TABLE OF CONTENTS

9605020048 960424
 PDR ADOCK 05000266
 PDR
 P

15.7 RADIOLOGICAL EFFLUENT TECHNICAL SPECIFICATIONS (RETS)

Figure 15.7.2-1

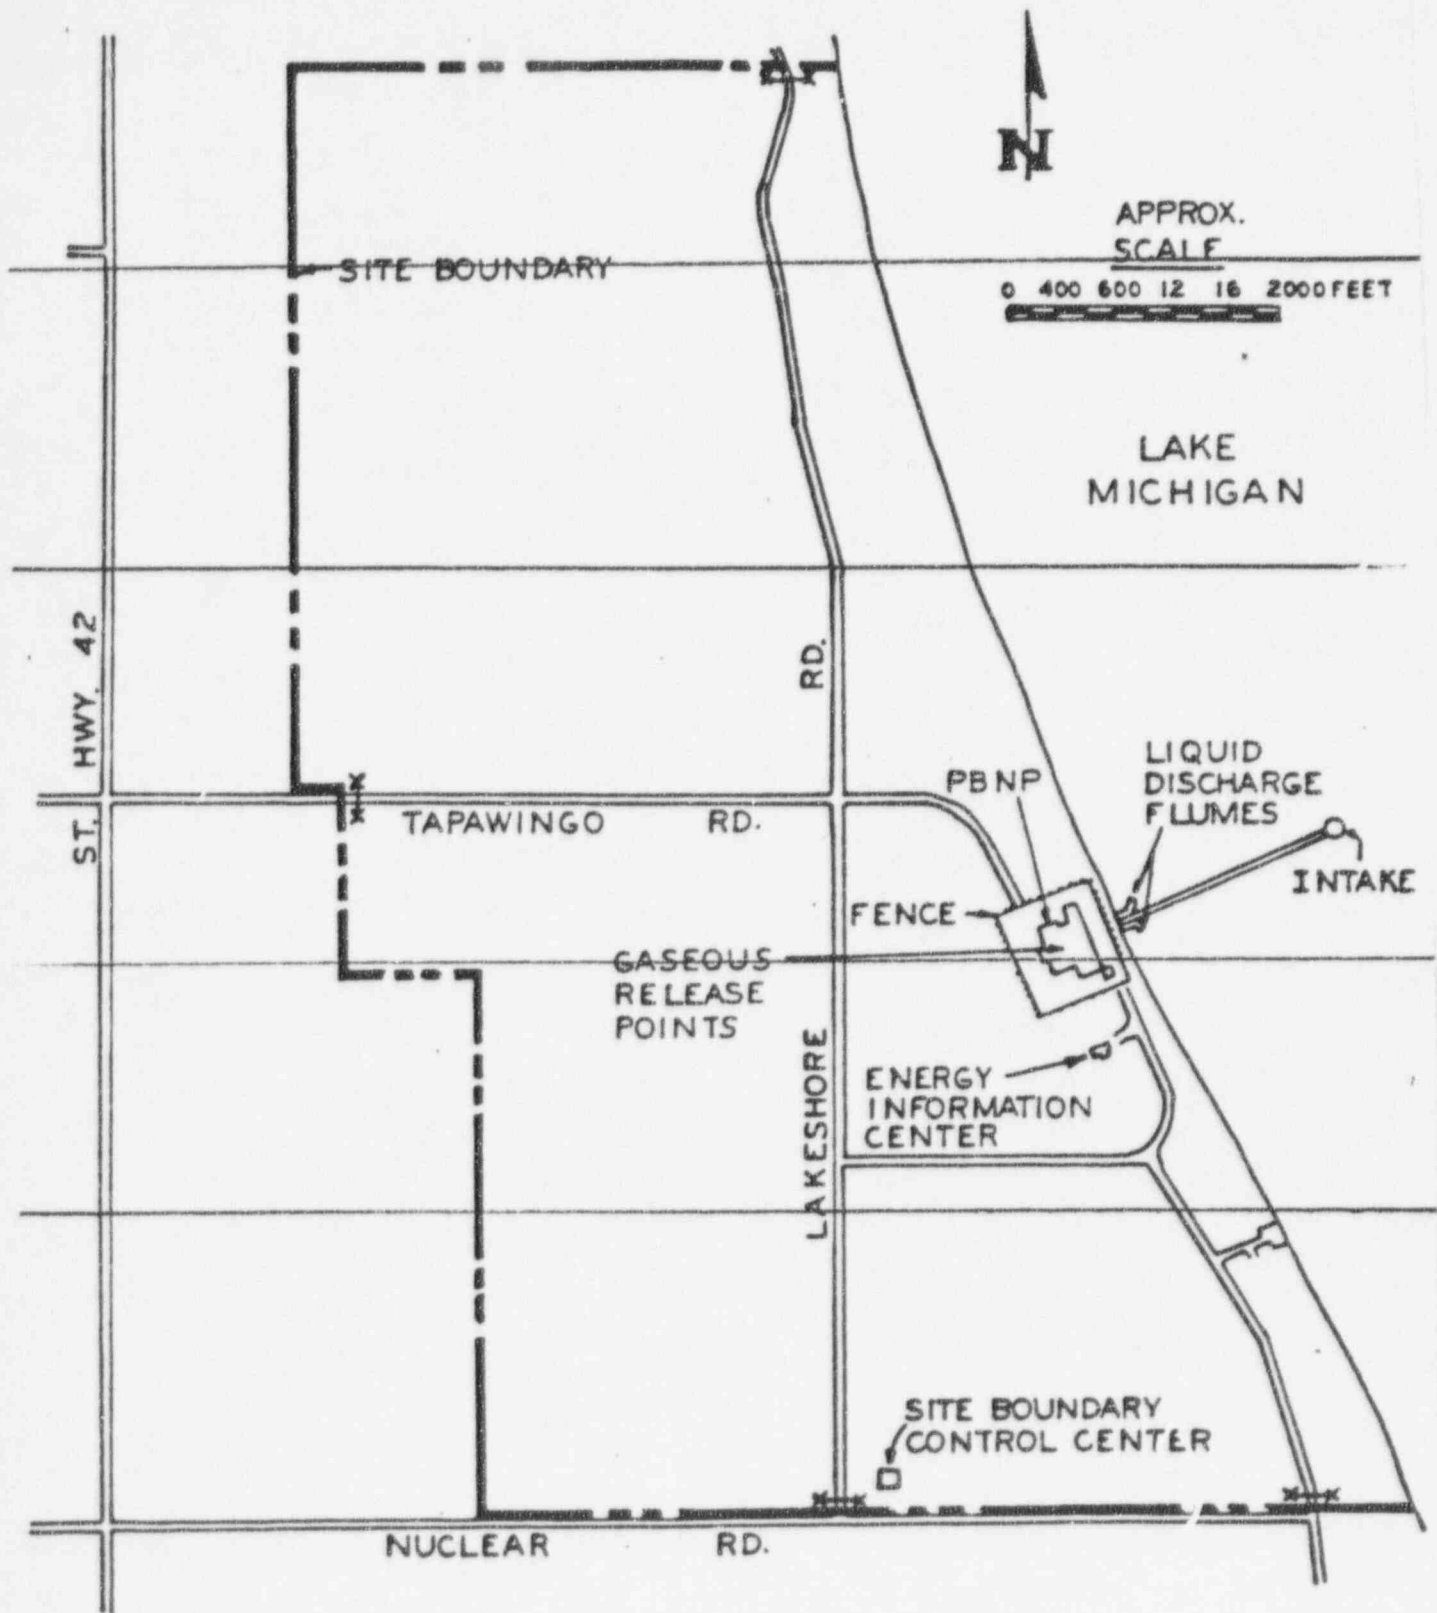
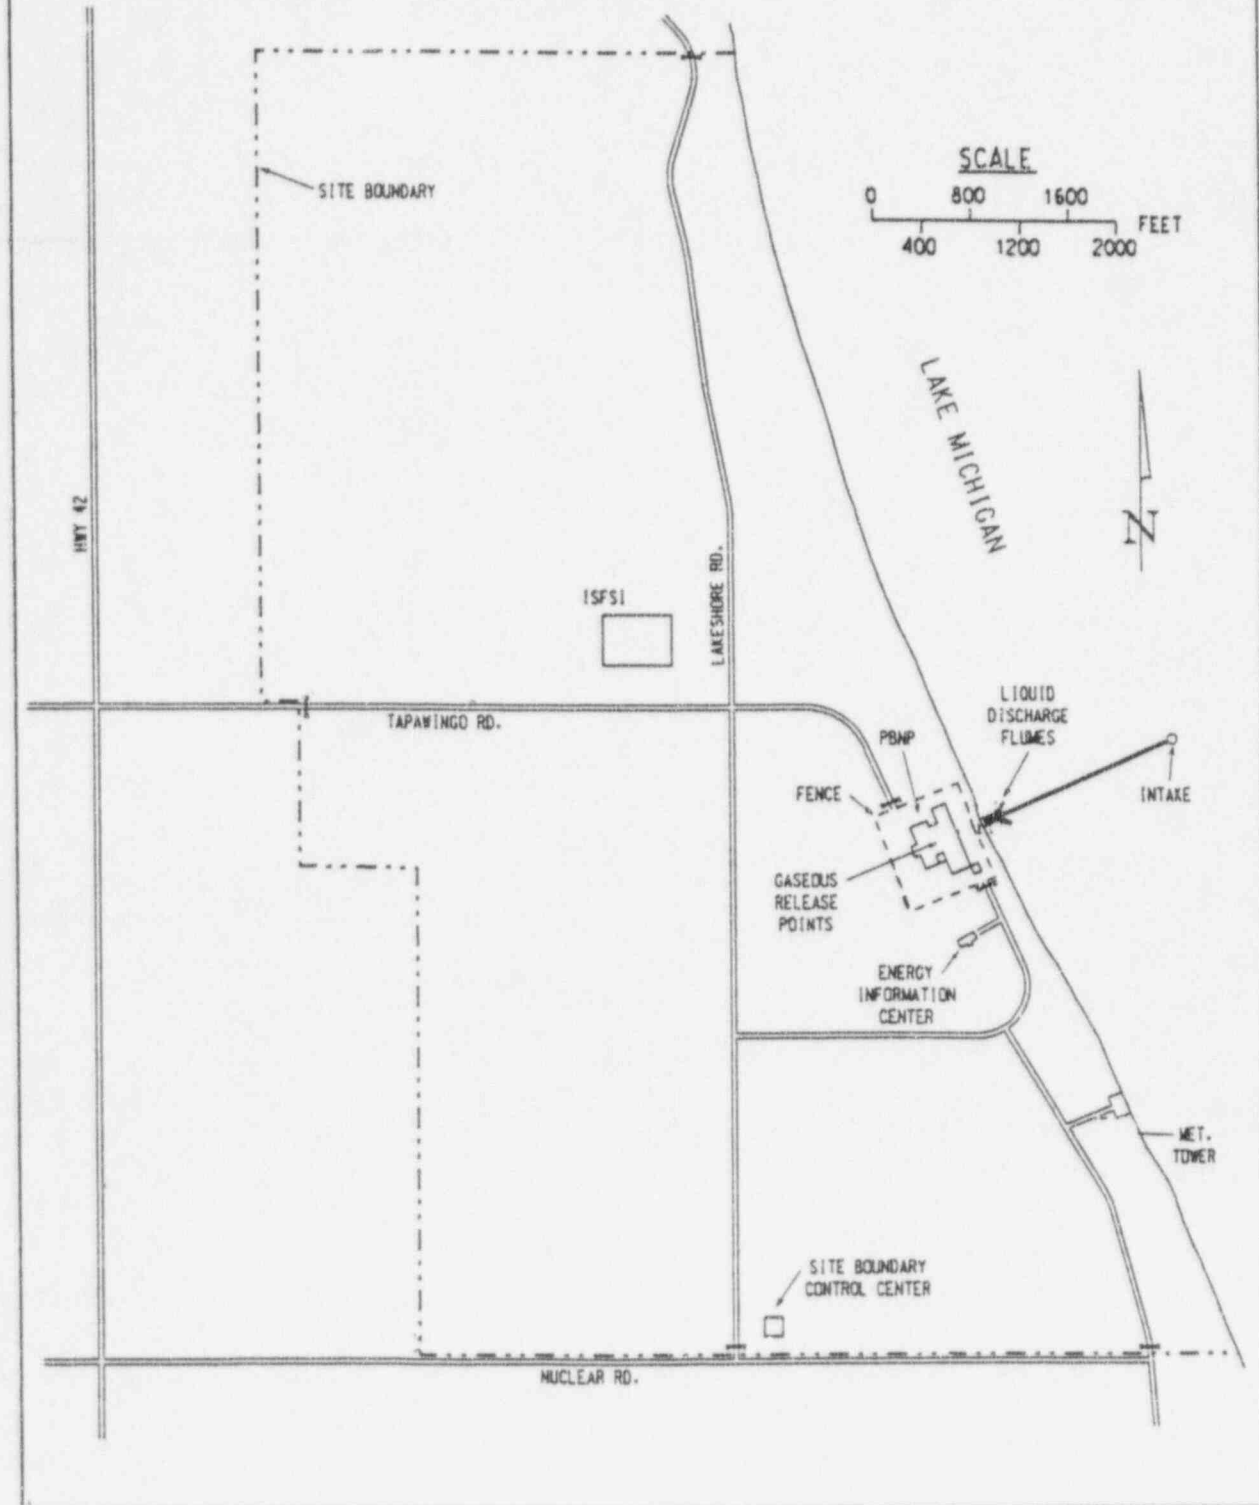
Figure 15.7.2-1 is a site map for the Point Beach Nuclear Plant Units 1 and 2. The site map shows the site boundary and points within the site boundary from which gaseous and liquid effluents are released. Fence locations are approximate.
